## Response to the Reviewers' Comments

The authors would like to thank the reviewers for the precious comments and suggestions on the technical contents and presentation of our manuscript "Runtime Power Management of Battery Electric Vehicles for Extended Range with Consideration of Driving Time," submitted to IEEE Transactions on Very Large Scale Integration (TVLSI.) This revised manuscript has been greatly improved thanks to the reviewers' invaluable advices. We have revised the manuscript faithfully following the reviewers's comments. We include the newly added or significantly modified parts in the revised version of the paper also in Response to Reviewers. We highlight the important technical content changes and set those parts in a red color in the revised paper.

Fig. 2: (a) Range-speed experimental data for Chevrolet Bolt [36] and (b) comparison with simulation results of the proposed EV power model.

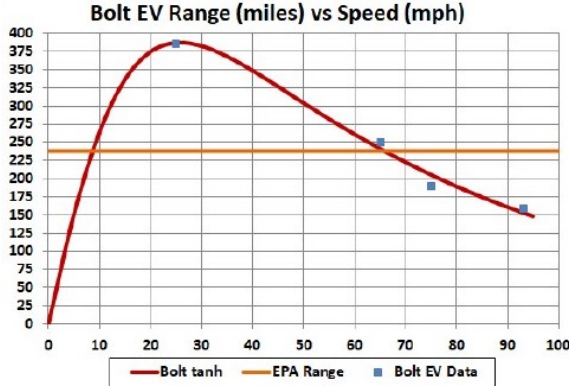
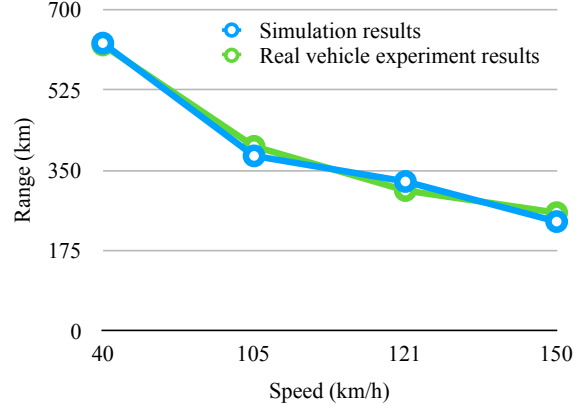
**R1-C2** It is not clear how to validate the power model of EV. As the author mentions that accuracy of power model is quite important, it is good to see the power model in this paper can be validated by some real measurement results.

Here goes how we extracted correct coefficients of the EV power equation. We use a vehicle simulator that supports EV as well, ADVISOR, to extract the coefficients of new vehicles starting from known vehicle specifications such as the aerodynamic resistance, rolling resistance, curb weight, and so on. Such data is often published in the users' manual, website and so forth. We further use the vehicle performance data such as the top speed, maximum acceleration, and so on, which are also available on the manuals and website. We iteratively run ADVISOR and derive the model coefficients so that all the known values match among each other. We evaluate the model accuracy with the range-speed real vehicle experiments as shown in Fig. 1(a), which has been published by [32], [33], [34], [35], [36]. We further refine the coefficients until all the available data values match well. Finally, the derived EV power model well matches with the range-speed experimental data as shown in Fig. 1(b) as well as the top speed and maximum acceleration, setting the aerodynamic resistance, rolling resistance, curb weight, etc. with the known (fact) values. The errors of the range-speed simulation is merely 1.4%, the time to approach 60 mph at departure is 7.8%, and the top speed is 3.0%, respectively. We revised the manuscript adding the following paragraph with a new figure in Section III-A on page 3 and 4.

We further evaluate the model accuracy with the range-speed real vehicle experiments as shown in Fig. 2(a) to confirm the derived power models are close enough to the real vehicle measurement data [32], [33], [34], [35], [36]. We refine the coefficients until all the available data values match well.

As a result, the derived EV power model well matches with the range-speed experimental data as shown in Fig. 2(b) as well as the top speed and maximum acceleration setting the aerodynamic resistance, rolling resistance, curb weight, etc. with the known values. The errors in the range-speed simulation is merely 1.4%, the time for 0-to-100 km/h error is 7.8%, and the top speed error is 3.0%, respectively.

Fig. 12: Velocity profile comparison with  $EDP$ ,  $E^2DP$  and  $E^3DP$  on Serrano Avenue in Anaheim Hills.

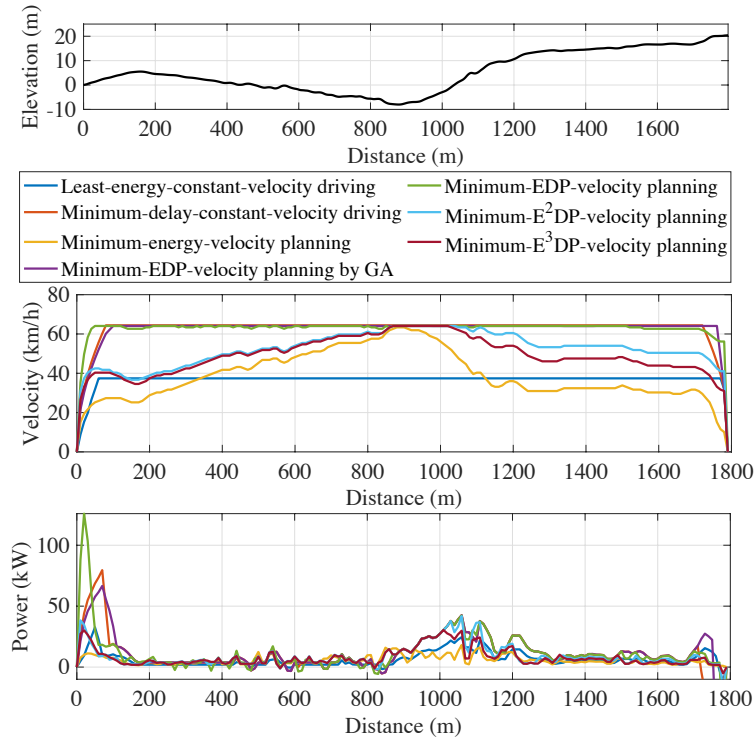
**R1-C3** The optimality of the proposed scheduling algorithm is unclear. The author should add several paragraphs to discuss this topic. It is also to see the comparison baseline is well accepted to show the advantage of the proposed algorithm.

Fig. 12 summarizes  $EDP$  of the least-energy-constant-velocity driving, the minimum-delay-constant-velocity driving, the minimum-energy-velocity planning, the velocity planning with  $EDP$ ,  $E^2DP$  and  $E^3DP$  as a metric on the road benchmarks and the minimum- $EDP$ -velocity planning with GA. The proposed velocity planning results in up to 46.2% improvements of  $EDP$  compared with the least-energy-constant-velocity driving. The driving velocity on a flat road is faster than that of the least-energy-constant-velocity driving at the expense of relatively little energy to save driving time. Then, the velocity decreases when climbing the following uphill to spend less motor torque, which saves more energy.

In addition,  $EDP$  of the proposed EDP-aware-velocity planning is merely 4.3% higher than that of the true EDP-minimum-velocity planning on average. Through this results, we confirm that the results of the proposed heuristics are close enough to the true optimal solutions.

We also updated Fig. 12 and Fig. 13:

Fig. 11: Histograms of velocity and acceleration for the proposed energy-aware-velocity planning methods without an acceleration constraint (a) and (b) and with an acceleration constraint (c) and (d), respectively.

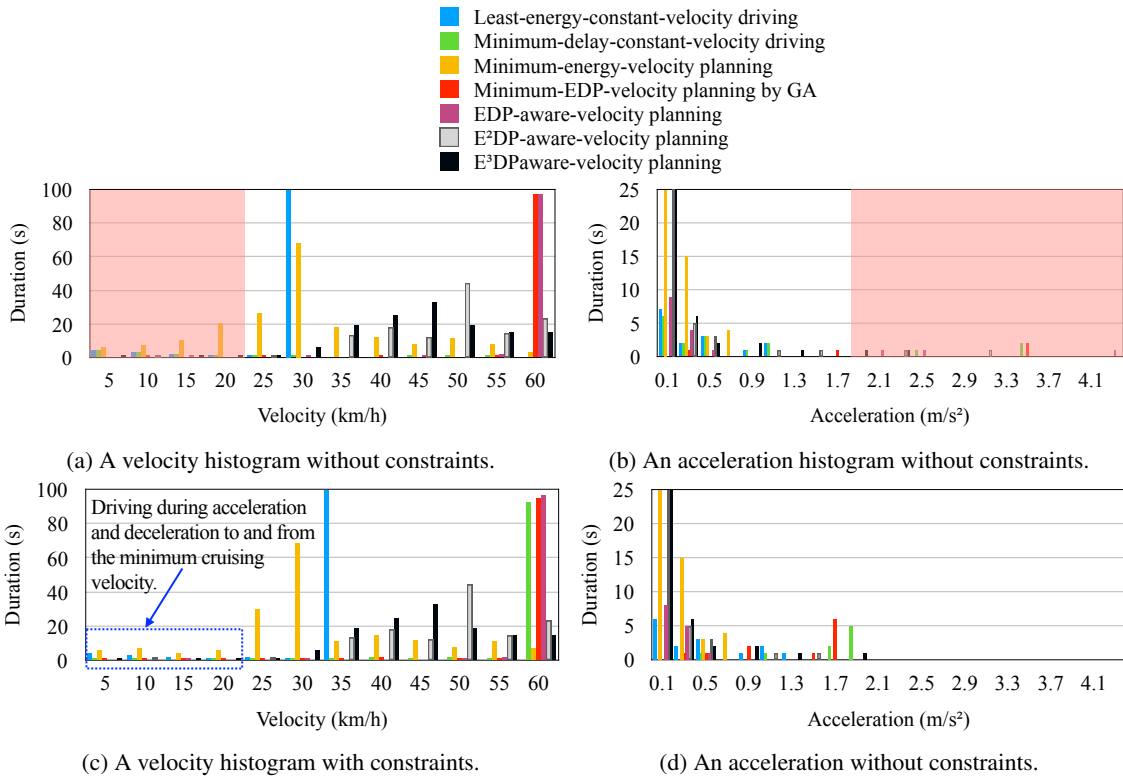
**R2-C2** It would be good to have more discussion on the assumptions of the approach and the experiments, e.g., how much can the velocity be changed in practical scenarios without impeding traffic and causing unsafe situations (also depending on the road conditions and whether it is urban or rural environment I suppose). Currently, there only seems to be one constraint on not slower than 10 km/h.

Fig. 11(a) and (b) show two histograms of the driving schemes in Fig. 12, which do not have velocity and acceleration constraints. We avoid a cruising velocity lower than 25 km/h and an acceleration higher than  $2.0 \text{ m/s}^2$  in this paper without loss of generality. The acceleration of  $2.0 \text{ m/s}^2$  is the same as the maximum acceleration of compact cars designed to be used primarily used in urban areas (13 seconds of 0 to 100 km/h time).

Fig. 11(c) and (d) shows the velocity and acceleration histograms with the constraints. Once we run the DP for the first time without constraints, we analyze the histogram, adaptively determine the minimum cruising velocity and maximum acceleration constraints, and run DP again. We keep the same constraints for online recomputation whenever unexpected interrupts occurs.

We quantize the velocity and acceleration values and make a histogram to analyze population of velocity and acceleration for the proposed energy-aware-velocity planning methods. Fig. 11(a) and (b) show two histograms of the driving schemes in Fig. 12, which do not have velocity and acceleration constraints. We avoid a cruising velocity lower than 25 km/h and an acceleration higher than  $2.0 \text{ m/s}^2$  in this paper without loss of generality. The acceleration of  $2.0 \text{ m/s}^2$  is the same as the maximum acceleration of compact cars designed to be used primarily used in urban areas (13 seconds of 0 to 100 km/h time).

Fig. 11(c) and (d) shows the velocity and acceleration histograms with the constraints. Once we run the DP for the first time without constraints, we analyze the histogram, adaptively determine the minimum cruising velocity and maximum acceleration constraints, and run DP again. We keep the same constraints for online recomputation whenever unexpected interrupts occurs.

Fig. 8: Benchmark altitude.

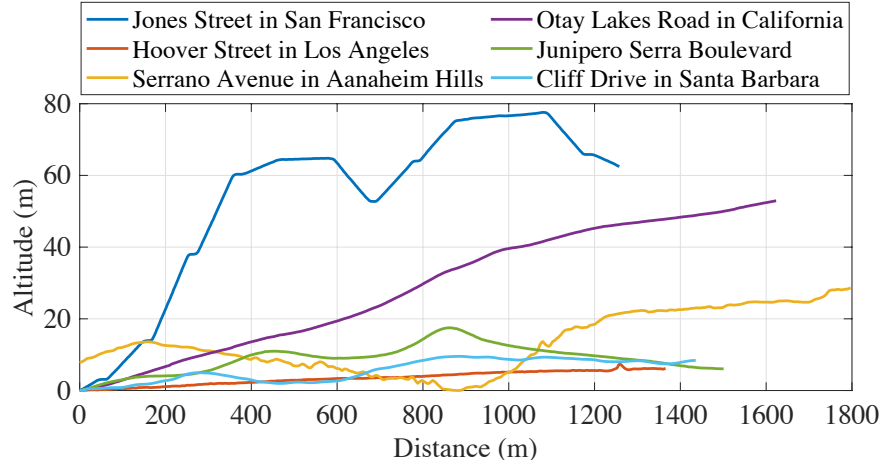
**R2-C3** Related to the last point, it would be good to have more discussion on the road benchmarks, e.g., how they are generated and how representative they are. The optimization results significantly depend on road slope. It would be good to use a variety of real road segments for testing.

**R2-A3** We appreciate the reviewer's comment and added six new real routes from various locations in California. The first three roads are in cities. Jones Street in San Francisco and Hoover Street in Los Angeles are two representative city landscapes such as hills and flat roads, respectively, and Cliff Drive in Santa Barbara is a mixture of those. The second two roads are in mountain areas: Serrano Avenue in Anaheim Hills and Otay Lakes Road in San Ysidro Mountain in California. The last road is Junipero Serra Boulevard connecting San

Fransisco and San Jose. The details of road data is summarized in Table II, and Fig. 8, which visualize the altitudes of the road benchmarks.
